Interactive comment on “The Effect of Instrumental Stray Light on Brewer and Dobson Total Ozone Measurements” by Omid Moeini et al.

Omid Moeini et al. (omidmns@yorku.ca)

Anonymous Referee #1

Figure 5: Example of Langley plot fitted to a modeled single Brewer data

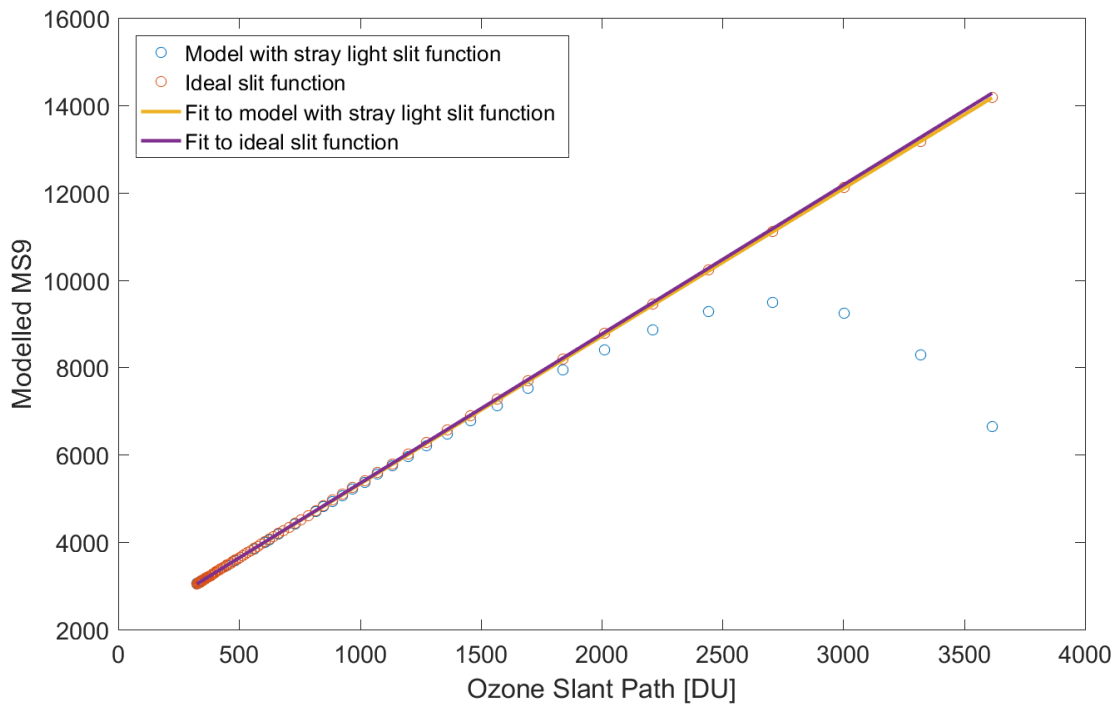
Line 15 I would like to see a plot showing what the Langely looked like without and without the stray light being added to the model

Following figure shows the Langley plot for Single Brewer with and without stray light. The plot is added to the manuscript:

“To calculate the ETC, the instrument absorption function using the solar spectrum (Chance and Kurucz 2010), Eqs. (1), (2) and retrieval algorithm of the Brewer (or Dobson) for an assumed constant amount ozone (325 DU in this study) is calculated and plotted as a function of ozone slant path. The best fit to the data with airmass less than 2 (less than 3 for the Dobson instruments) is found and extrapolated to zero airmass. Figure 5 shows the best fit to a single Brewer data:

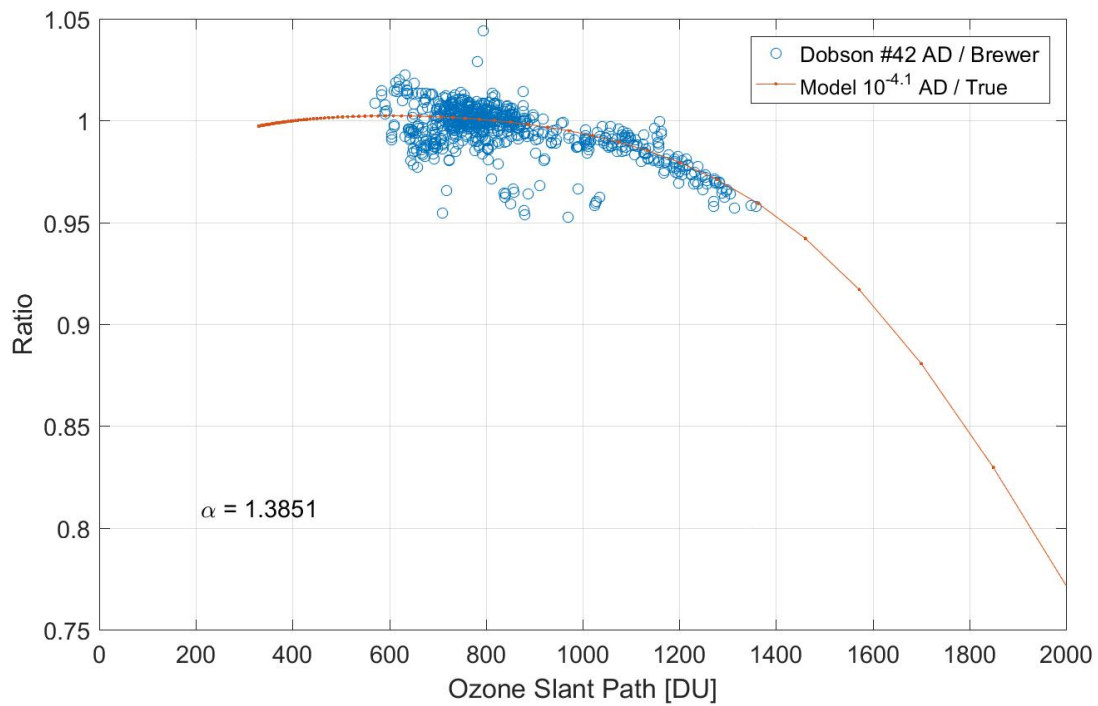
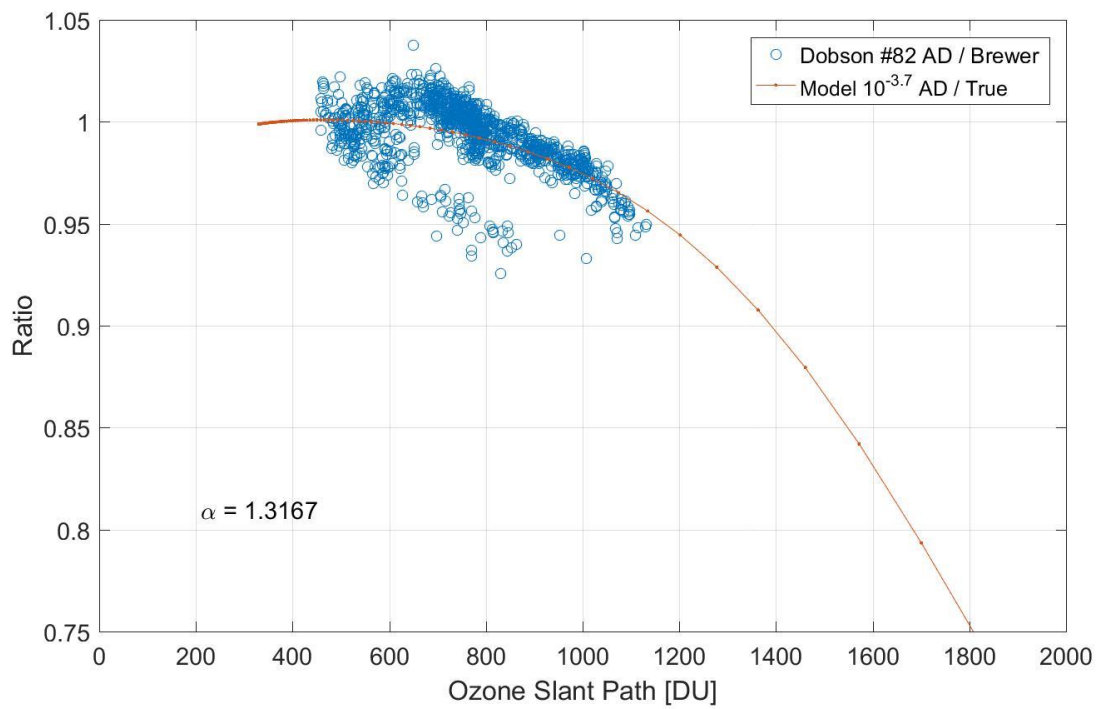
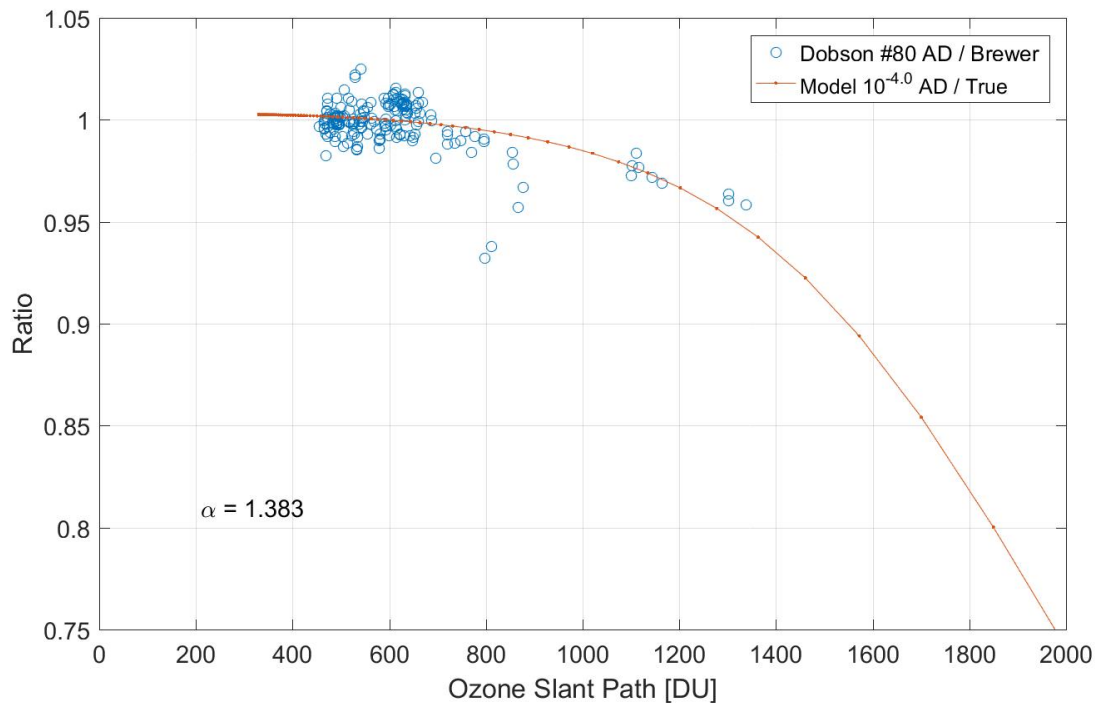
Line 24-26 It seems a bit curved. You need to calculate how close the measured values are to what you expect from your model.

The manuscript is revised and the following plots and statement are added:

"As it is shown in Fig. 9, the physical model developed in this study suggests $10^{-3.7}$, $10^{-4.1}$, and $10^{-4.0}$ level of stray light for Dobson #82, 42, and 80 respectively.
